2003 International Residential Code Errata

ERRATA TO THE 2003 INTERNATIONAL RESIDENTIAL CODE

Errata to the Third Printing, November 2003

**FIGURE R403.3(2)
AIR-FREEZING INDEX
AN ESTIMATE OF THE 100-YEAR RETURN PERIOD**

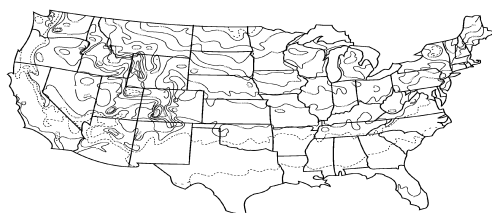
FIGURE R403.3(2) AIR-FREEZING INDEX AN ESTIMATE OF THE 100-YEAR RETURN PERIOD

Replace figure and revise the “3000” contours in NY, VT, NH and Maine to read “2000”.
